# HISTORIC AND DESIGN REVIEW COMMISSION

**HDRC CASE NO:** 2022-239  
**ADDRESS:** 702 HAYS ST  
**LEGAL DESCRIPTION:** NCB 540 BLK 11 LOT A16  
**ZONING:** R-5, H  
**CITY COUNCIL DIST.:** 2  
**DISTRICT:** Dignowity Hill Historic District  
**APPLICANT:** Kuba Zarobkiewicz/ZAROBKIEWICZ KUBA  
**OWNER:** Kuba Zarobkiewicz/ZAROBKIEWICZ KUBA  
**TYPE OF WORK:** Construction of a rear addition, exterior modifications, window replacement, rehabilitation, roofing material change  
**APPLICATION RECEIVED:** May 06, 2022  
**60-DAY REVIEW:** Not applicable due to City Council Emergency Orders  
**CASE MANAGER:** Edward Hall

**Historic and Design Review Commission**  
***Design Review Committee Report***

NEW RESIDENCE ADDITION & STUDIO UNIT FOR  
KUBA & KIMBERLY ZAROBKIEWICZ  
702 HAYS ST.  
SAN ANTONIO, TEXAS 78202

EXTERIOR ELEVATIONS  
MAIN HOUSE

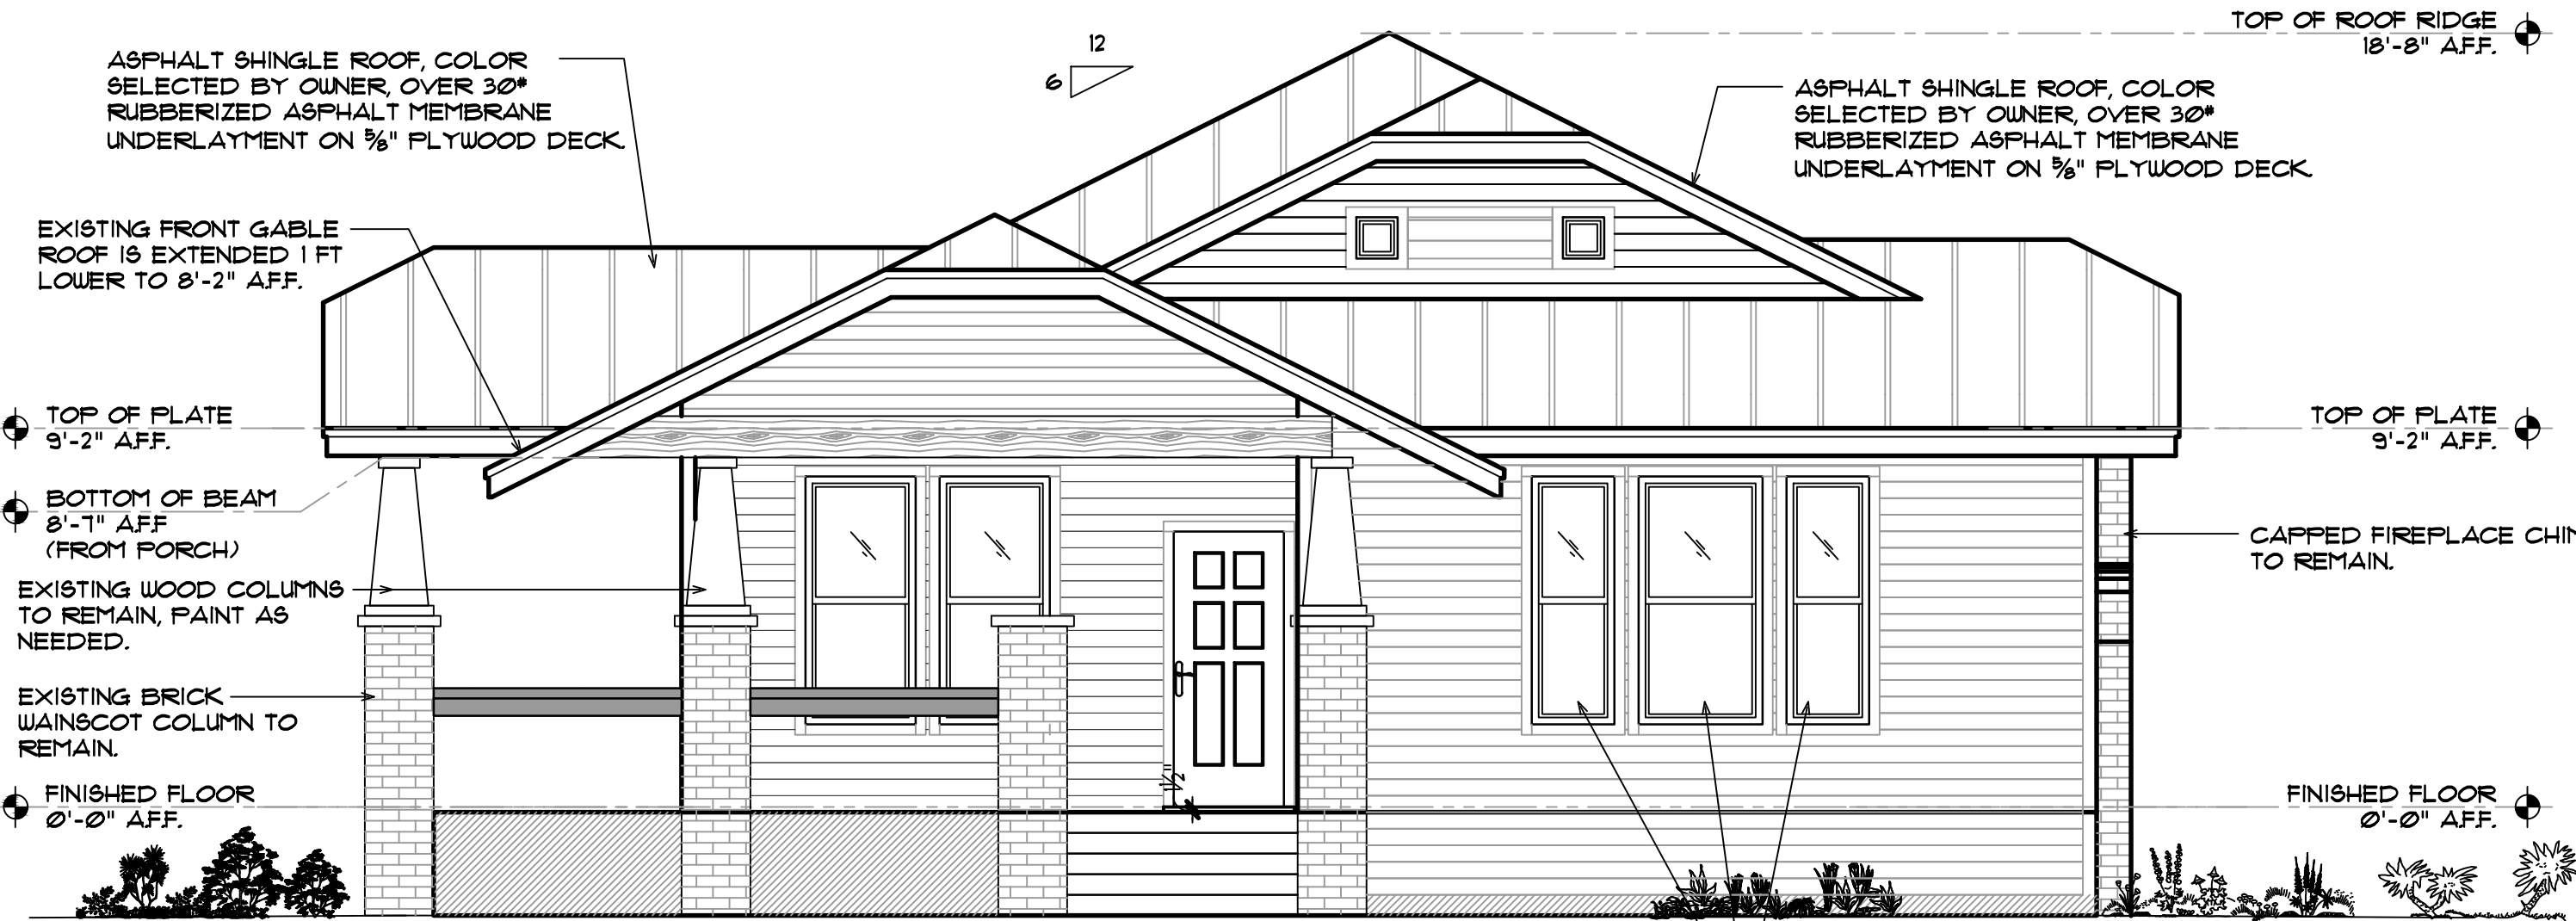
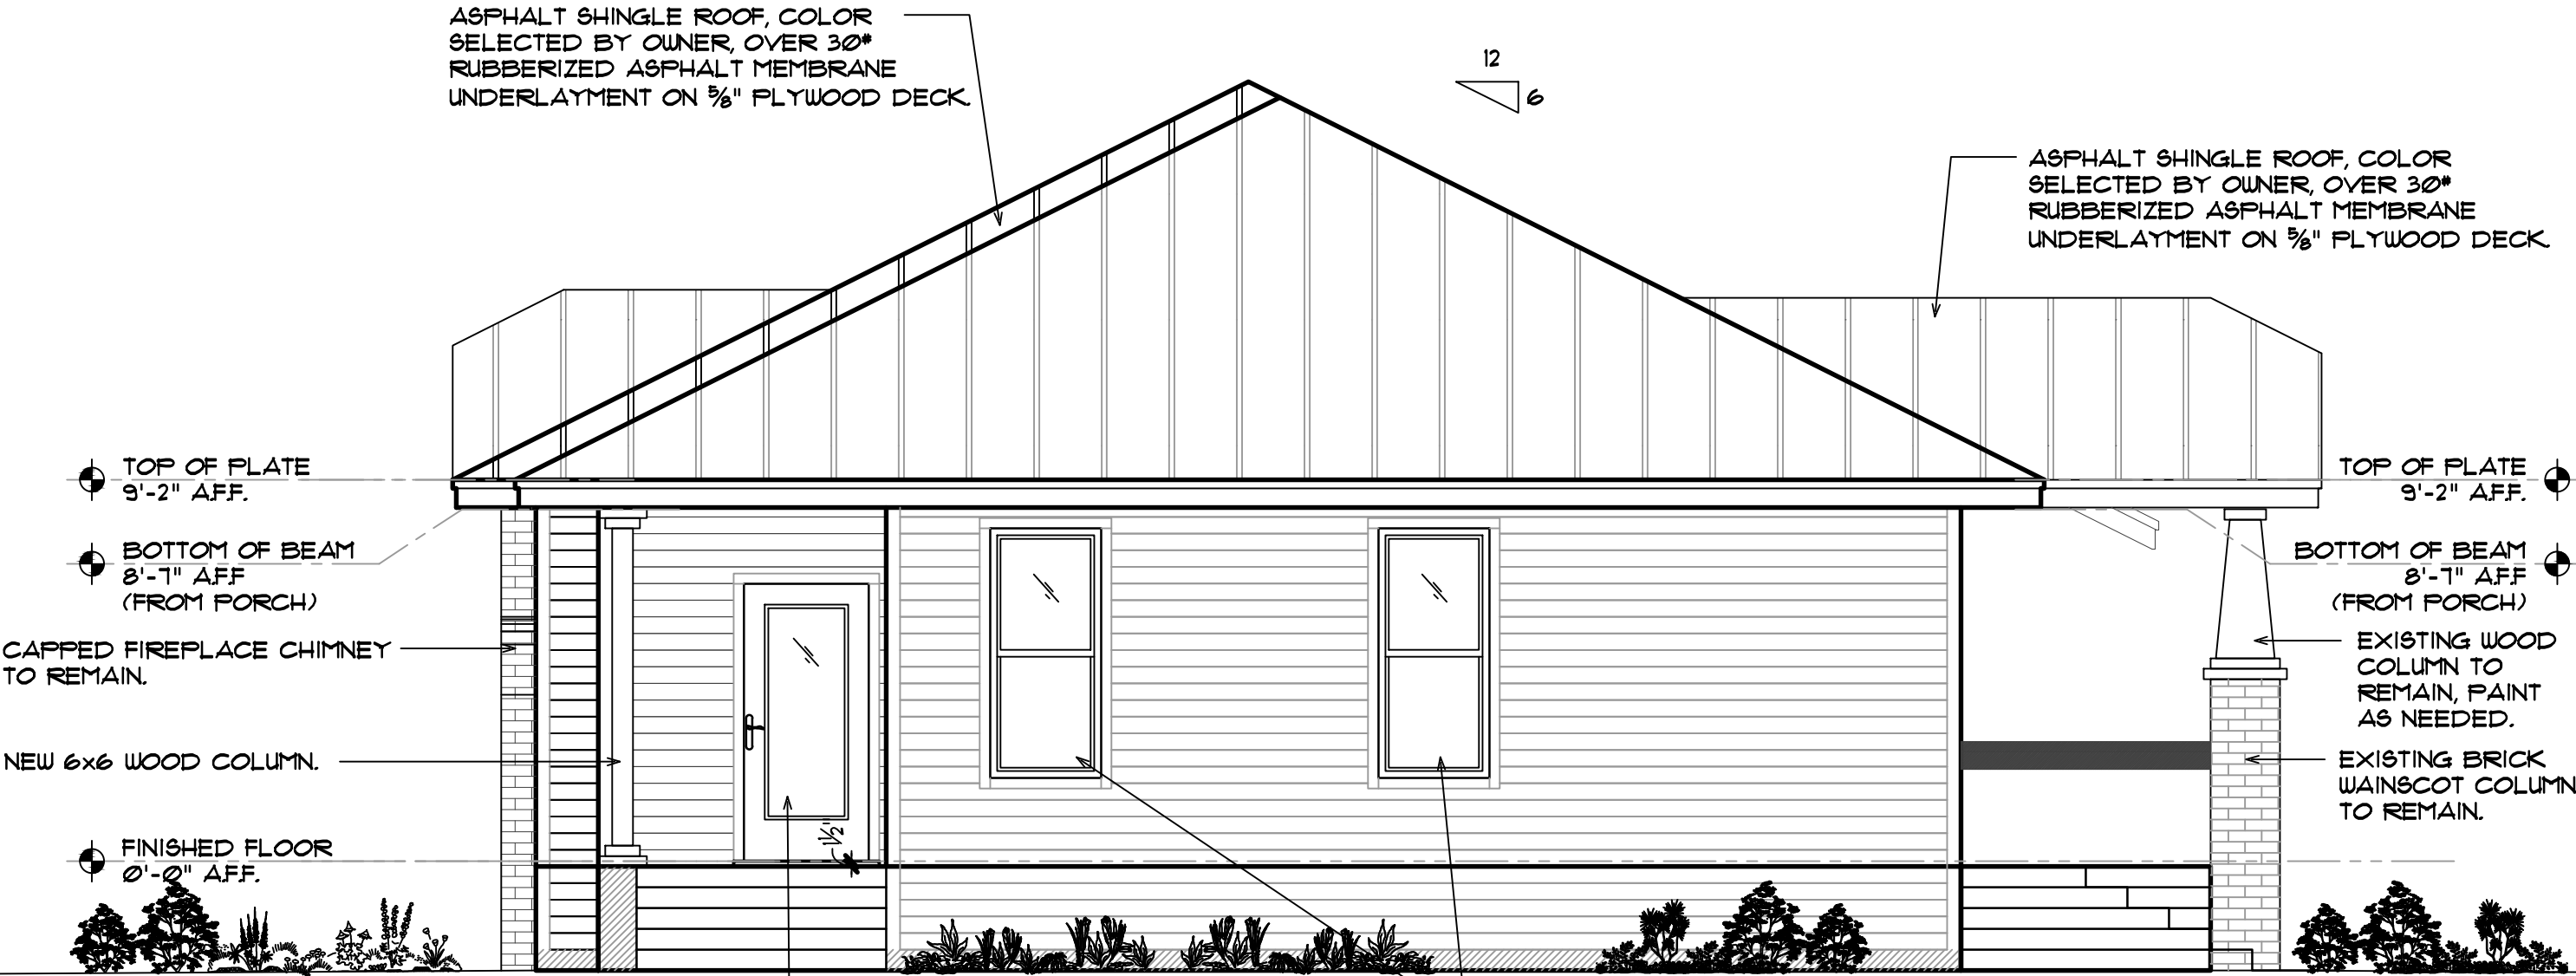
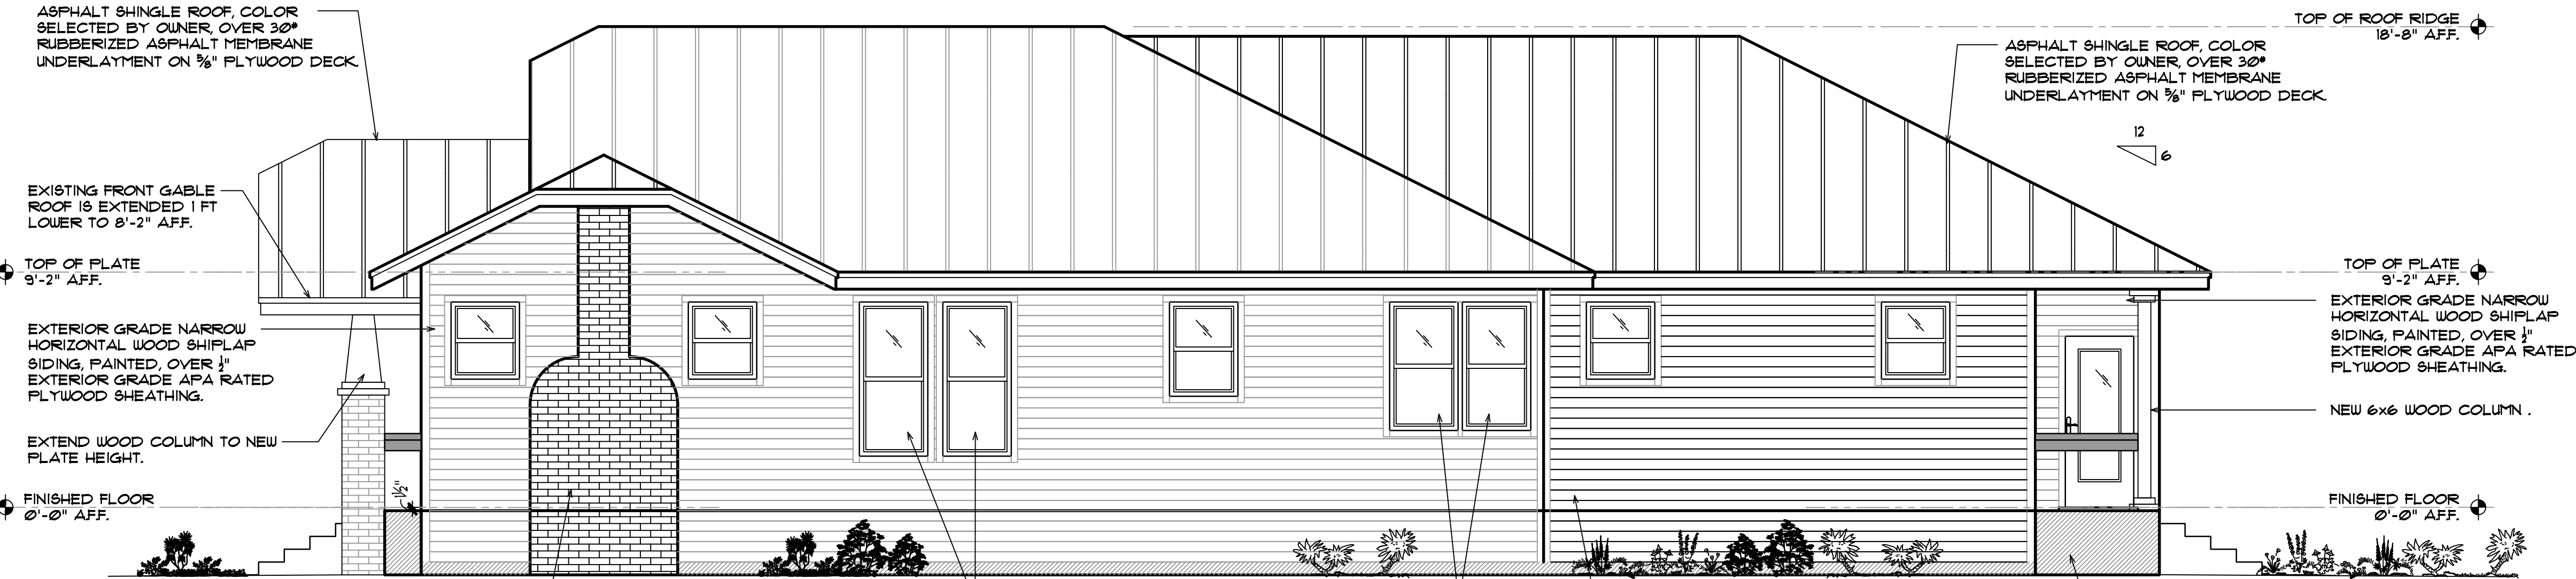
REVISIONS SUBMITTED TO ADDRESS COMMENTS FROM OHP STAFF AND THE DRC - THESE REVISIONS ARE NOT REFLECTED IN STAFF'S FINDINGS OR RECOMMENDATIONS.
